Request	-	Special Use Permit for a new Community Center
Location	-	2405 Stickney Avenue
Applicant	-	James Sherman New Covenant Church of the Living God 2405 Stickney Avenue Toledo, OH 43608
Design Professional	-	Anthony Coronado Midwest Church Design + Construction 634 Eckel Road Perrysburg, OH 43551

The staff recommends that the Toledo City Plan Commission recommend approval of SUP25-0021, a Special Use Permit for a new Community Center at 2405 Stickney Avenue, to the Toledo City Council, for the following three (3) reasons:

SPECIAL USE PERMIT
TOLEDO CITY PLAN COMMISSION
REF: SUP25-0021
DATE: August 14 2025
TIME: 2:00 P.M.

SITE PLAN

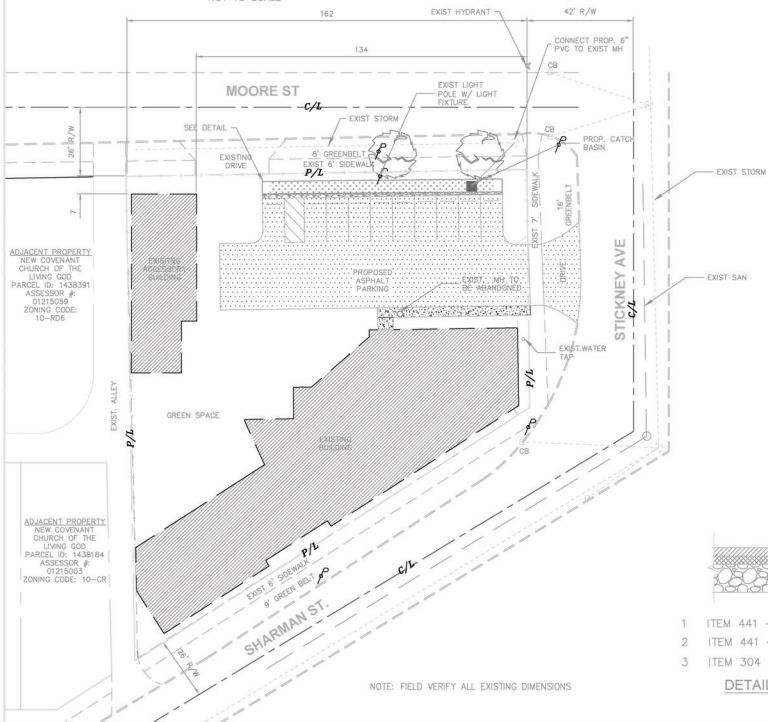
TMC§1107.1700 requires one (1) of the proposed parking spaces to be van accessible in accordance with the Americans with Disabilities Act. This van-accessible space is shown; however, accessible parking must be located to provide the shortest path of travel to the building's accessible entrance. As such, the van-accessible space must be moved so that it is the closest parking space to the entrance. This requirement has been included as a condition of approval.

TMC§1107.1202 *Setbacks* requires the proposed parking lot to be set back at least fifteen feet (15') from Moore Street and Stickney Avenue. The parking lots are currently set back ten feet (10') from Moore St and Stickney Ave. This is discussed in more detail below.

TMC§1108.0202 *Frontage Greenbelt* requires a fifteen foot (15') wide frontage greenbelt along both Moore Street and Stickney Avenue. The site plan depicts ten foot (10') wide frontage greenbelts along Moore Street and Stickney Avenue. The proposed parking lot will need to be shifted five feet (5') south and five feet (5') west to accommodate the required fifteen foot (15') wide frontage greenbelt. This should not be difficult as there are grass areas with a minimum dimension of five feet (5') in both of these directions, although the proposed sidewalk on the southern end of the parking lot will become flush with the building. This has been included as a condition of approval.

Lastly for TMC§1108.0202 *Frontage Greenbelt*, stormwater treatment facilities may occupy up to fifty percent (50%) of the frontage greenbelt. The proposed stormwater treatment swale appears to occupy more than fifty percent (50%) of the Moore Street greenbelt. Staff believes the required increase in greenbelt width will bring the stormwater treatment swale's occupation of the greenbelt below fifty percent (50%). Even so, the assurance that the stormwater treatment swale occupies no more than fifty percent (50%) of the greenbelt has been included as a condition of approval.

18. Bicycle parking spaces shall meet the standards of TMC§1107.0902. **Pole/rack details shall be submitted to the Planning Director.**
19. Pursuant to TMC§§ 1107.1202 & 1108.0202 the proposed parking area shall be shifted to ensure a fifteen-foot (15') setback and frontage greenbelt on both Moore Street and Stickney Avenue. **Not acceptable as depicted. A revised site and landscape plan shall be submitted to the Plan Director depicting the required parking lot setback.**

21. Pursuant to TMC§1108.0202 stormwater treatment facilities may occupy up to fifty percent (50%) of each frontage greenbelt. **Not acceptable as depicted. A revised landscape plan shall be submitted to the Plan Director depicting the stormwater treatment facilities less than fifty percent (50%) of each frontage greenbelt.**

LANDSCAPE PLAN

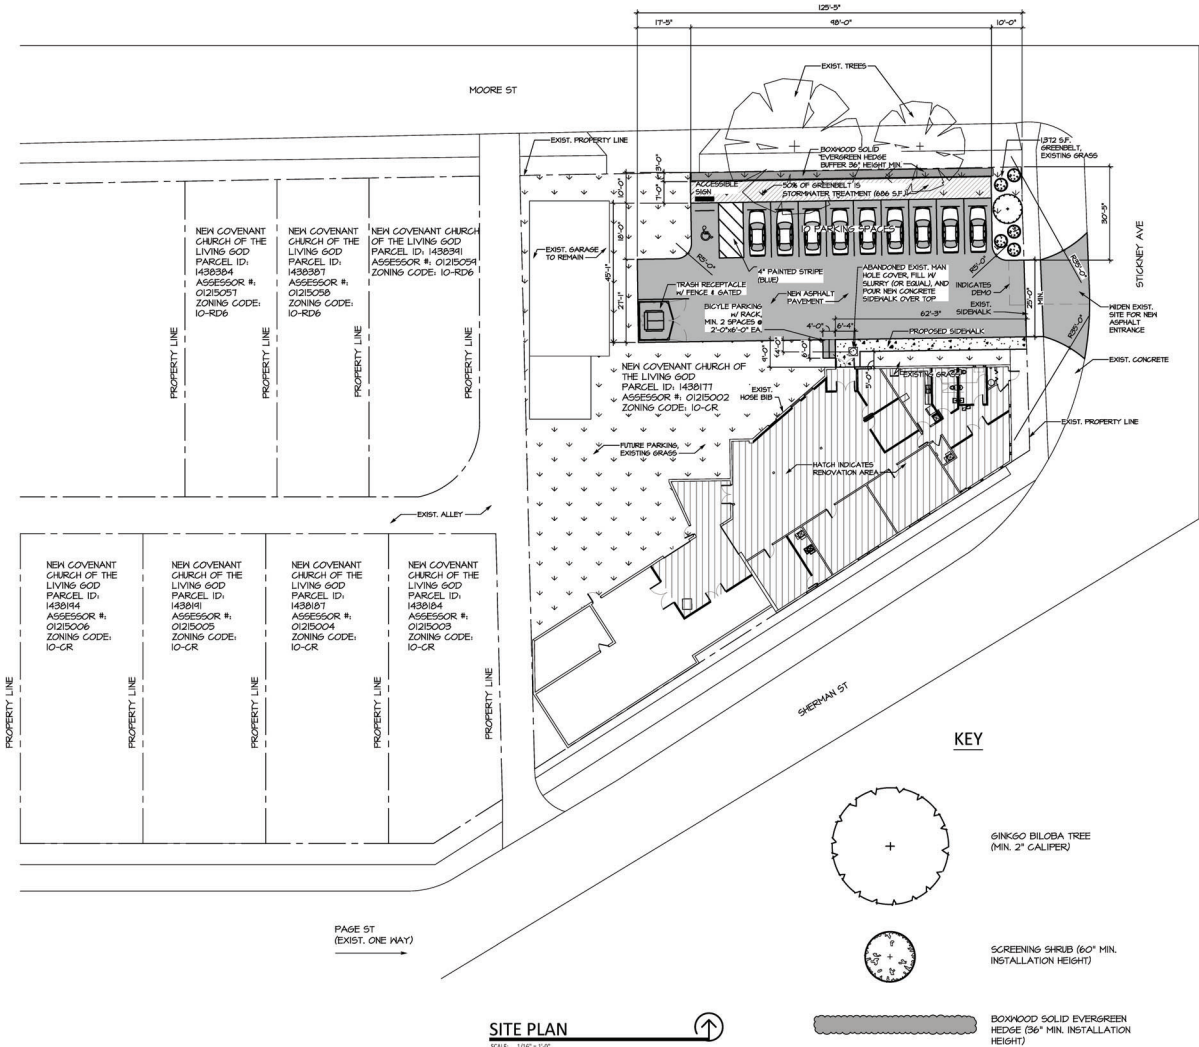
TMC§1108.0202 *Frontage Greenbelt* also requires at least one (1) tree for every thirty feet (30') of frontage and a solid evergreen hedge planting within the Moore Street and Stickney Avenue frontage greenbelts. Sufficient evergreen screening has been provided; however, only one (1) new tree planting is proposed. An additional four (4) trees are required within the Moore Street greenbelt and two (2) trees are required within the Stickney Avenue greenbelt. The existing trees identified on the plan are within the right-of-way and – as stated in TMC§1108.0202(A) – may not be used towards frontage greenbelt requirements. The inclusion of these additional trees on a revised landscape plan has been included as a condition of approval.

TMC§1108.0204 *Parking Lot Landscaping* requires two (2) canopy trees and six (6) shrubs for every ten (10) parking spaces within parking lots. As such, two (2) canopy trees and six (6) shrubs are required for the parking lot's interior landscaping. The depiction of these additional trees on a revised landscape plan has been included as a condition of approval.

20. Pursuant to TMC§1108.0202 the frontage greenbelts along Moore Street and Stickney Avenue require at least one (1) tree for every thirty feet (30') of frontage. **Not acceptable as depicted. A revised landscape plan shall be submitted to the Plan Director depicting a minimum of four (4) trees within the Moore Street greenbelt and two (2) trees within the Stickney Avenue greenbelt.**

22. Pursuant to TMC§1108.0204 two (2) canopy trees and six (6) shrubs are required within parking lots for every ten (10) parking spaces. **Not acceptable as depicted. A revised landscaping plan shall be submitted to the Plan Director depicting a minimum of two (2) trees and six (6) shrubs within or immediately adjacent to the proposed parking lot.**
